FIRST DRAFT MINUTES

October 18, 2012 Standards Committee Meeting

RE: Minutes from the October 18, 2012 Standards Committee Meeting

SPECIFICATION, SPECIAL PROVISIONS AND DRAWINGS
REVISION TO STANDARD SPECIFICATIONS AND DRAWINGS

EXISTING STANDARD DRAWINGS 605-CNCC-02 CONCRETE CENTER CURB TYPE B (WITH MARKUPS)

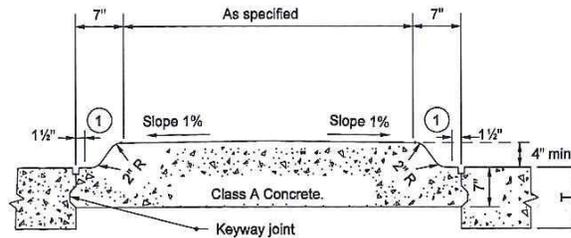
Revise 605.06 to require that yellow paint be applied on concrete center curb noses when shown on the Standard Drawings and revise the drawings to show yellow paint on curb types B through D.

- ① Curb radii and batter to conform to Type B curb, as shown on Standard Drawing E 605-CCSJ-01.
- ② Apply yellow paint to nose of center curb.

BACKUP 01 EXISTING STANDARD DRAWINGS 604-SWCR-03 SIDEWALK CURB RAMP TYPE A (SEE PROPOSAL SHEET)

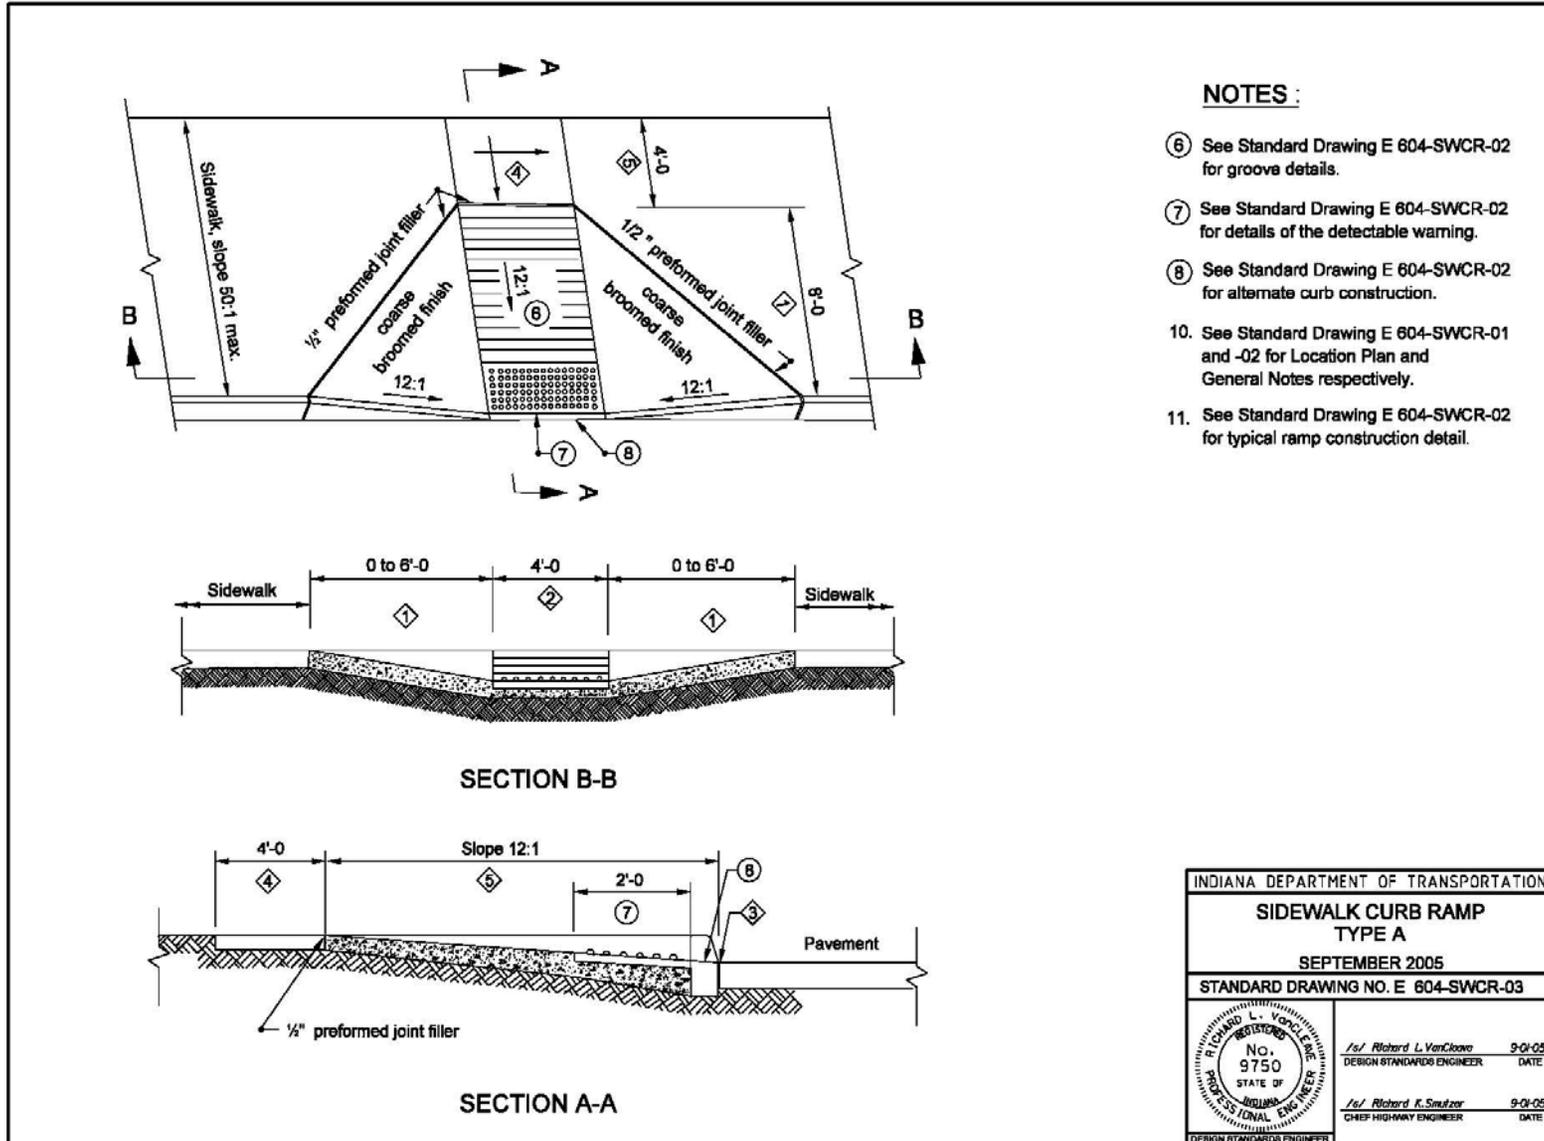
Also, there is contractor confusion on when curb ramps should be painted yellow. Normally only the part of the curb ramp that is a trip hazard should be painted.

PROPOSED SOLUTION: Revise 604.03 so that yellow paint is only applied if required (i.e. if the side slopes will have pedestrian cross traffic and they will be steeper than 12:1).
